**MISSISSIPPI DEPARTMENT OF TRANSPORTATION**

**SECTION 904 -NOTICE TO BIDDERS NO. 506**

**SUBJECT: Pay Item Correction**

**PROJECT: BR-0008-05(037) / 105344301 – Tallahatchie County**

WORKING NUMBER: 1 OF 18  
SHEET NUMBER: 8003

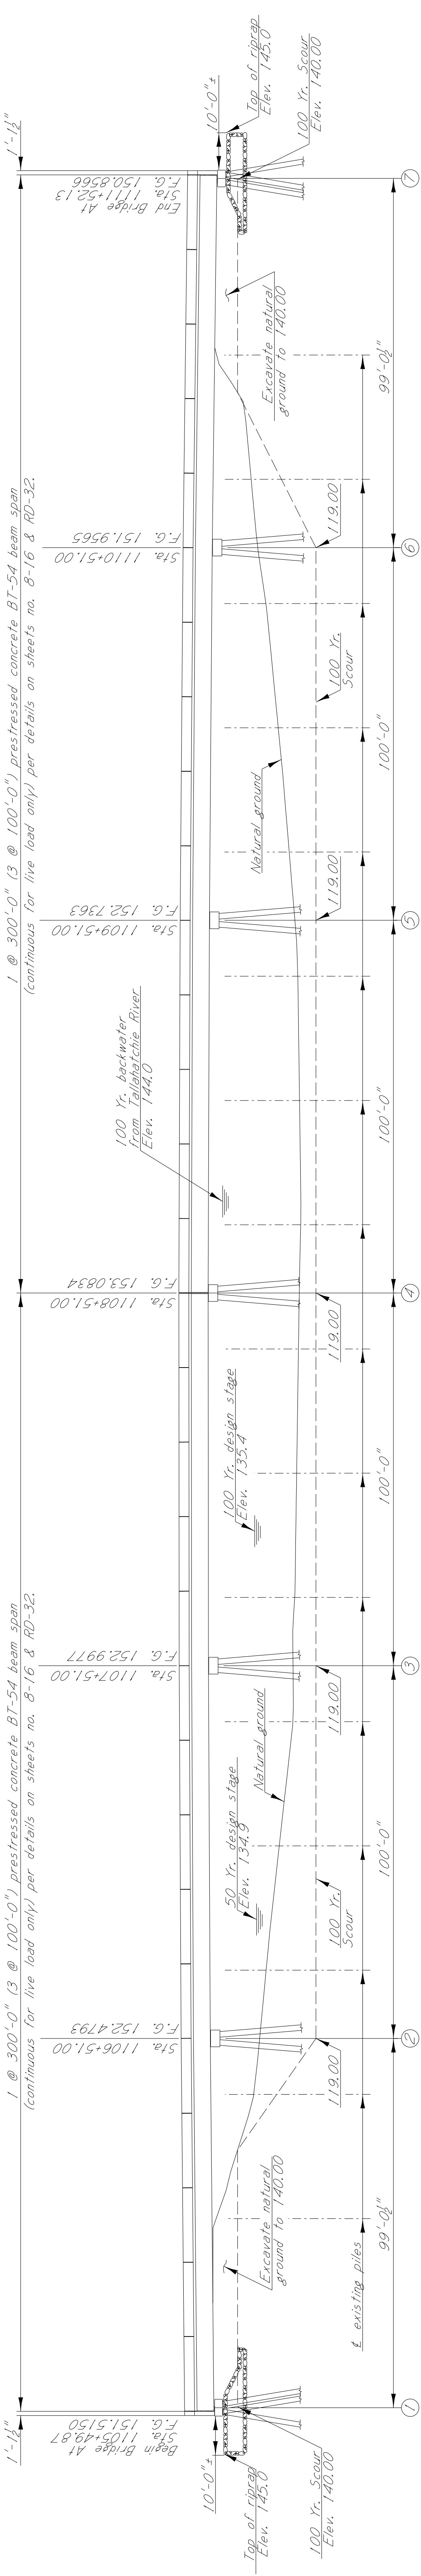
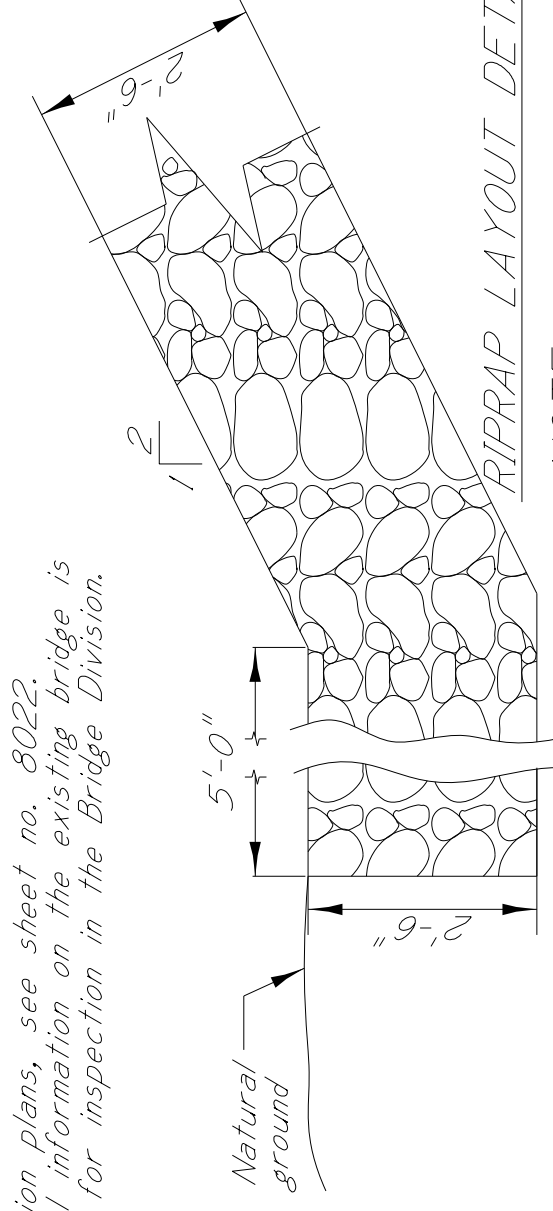
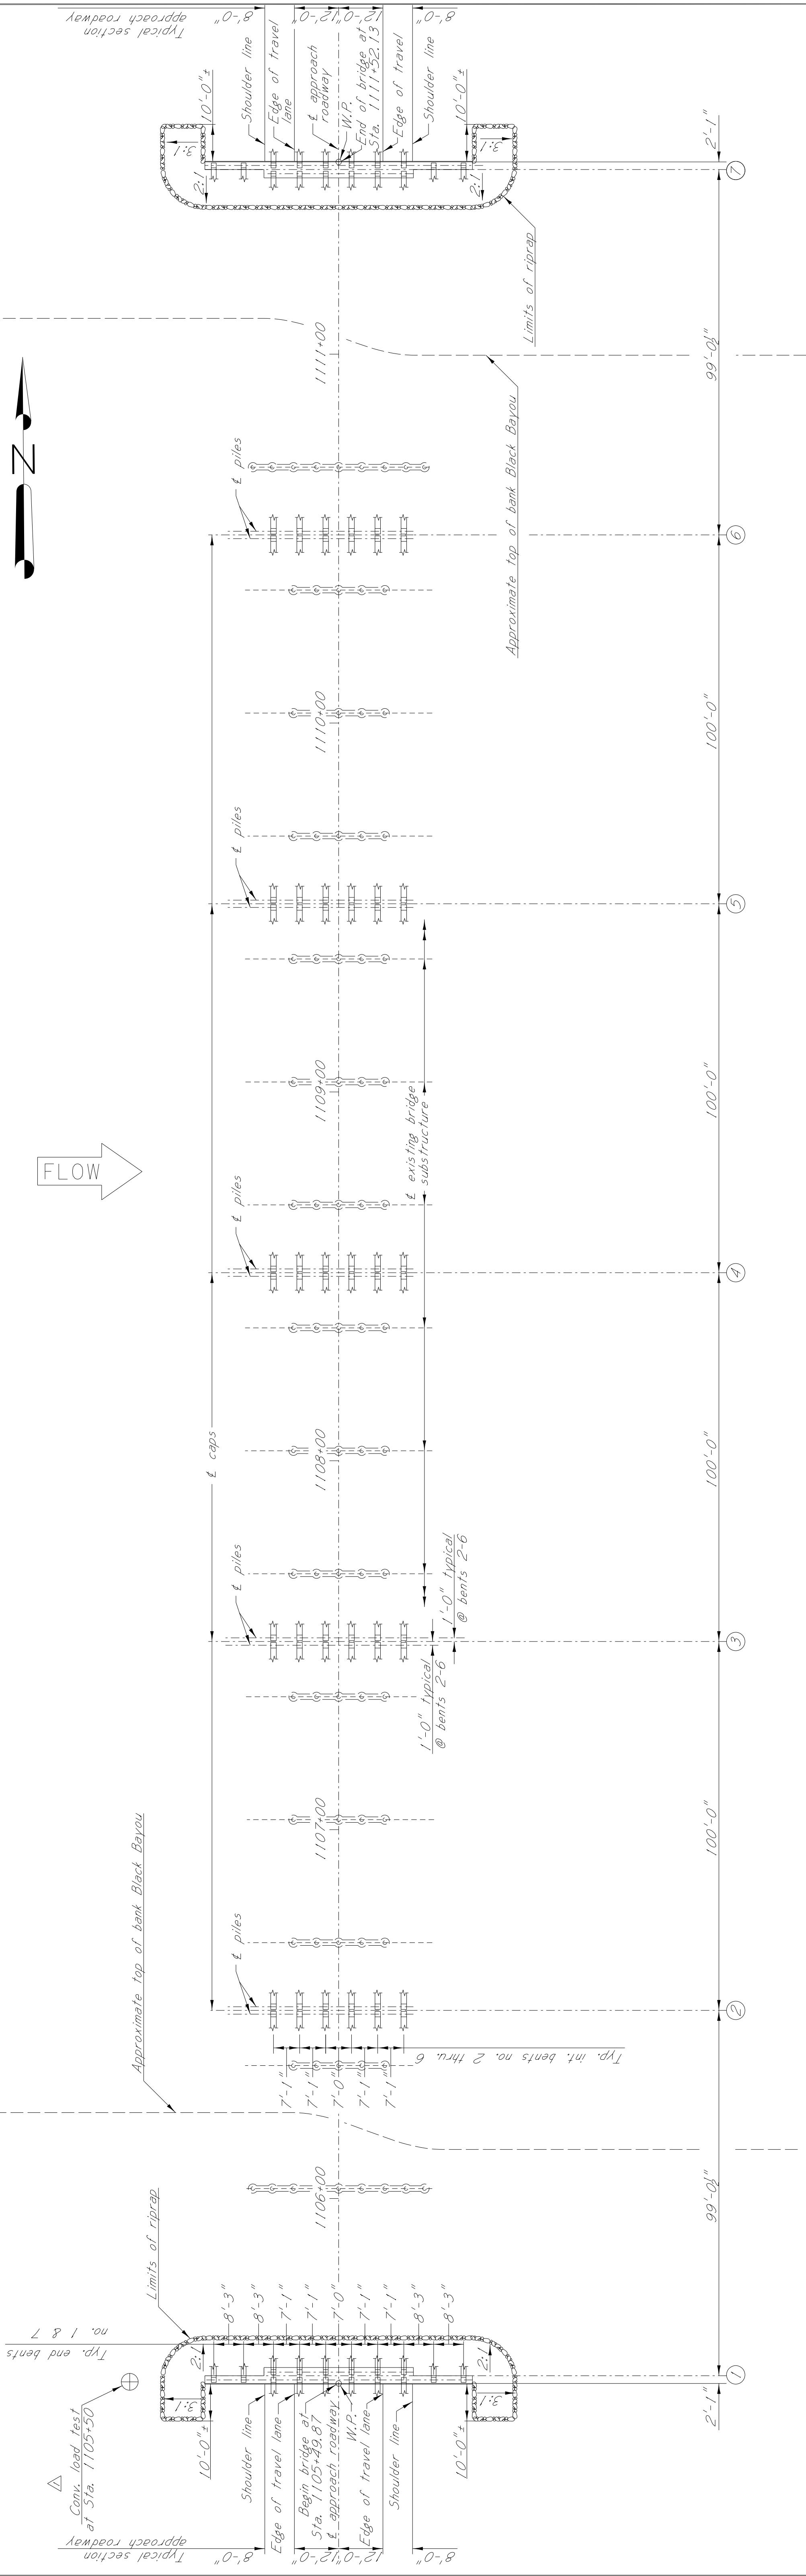
BRIDGE DIVISION		
REVISIONS		
DATE	SHEET NO.	BY
01-10-18	8002	B. Jones
01-10-18	8003 & 8004	L. Burr

DESIGNED BY	CONTRACT NO.	PROJECT NUMBER	WORKING NUMBER
DATE	BR-0008-05(037)	BR-0008-05(037)	2 OF 18
REVISION	ISSUE DATE	ISSUE DATE	SHEET NUMBER
Added Detail	11-08-2017	11-08-2017	8004

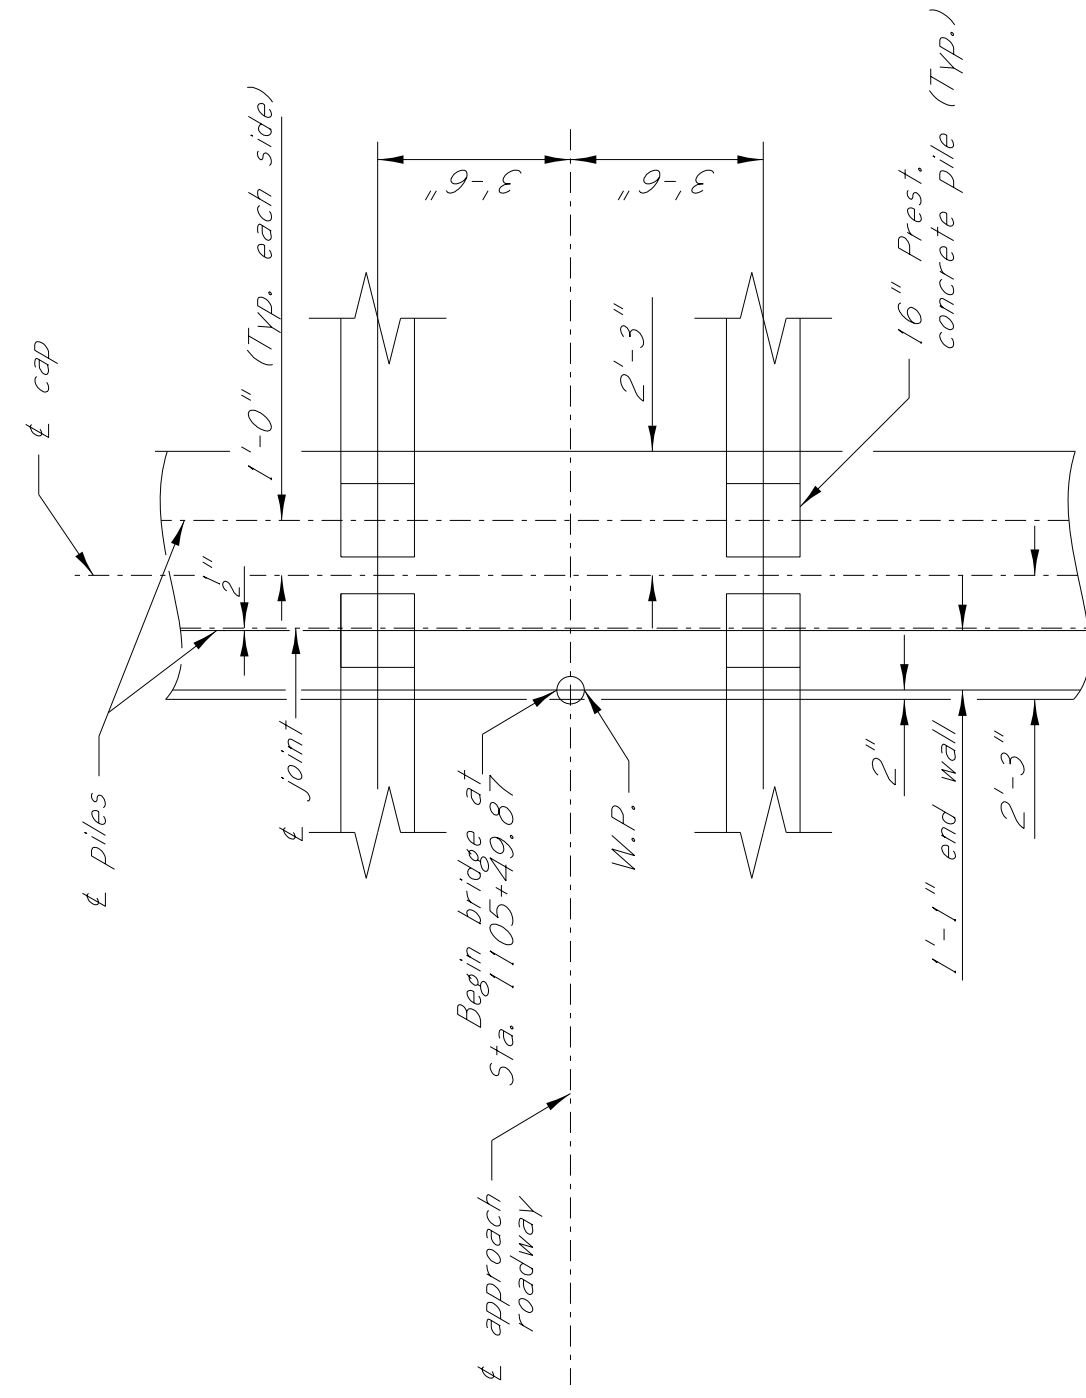
NOTE:  
Detail shown for end bent no. 1, end bent no. 7 similar by orientation.
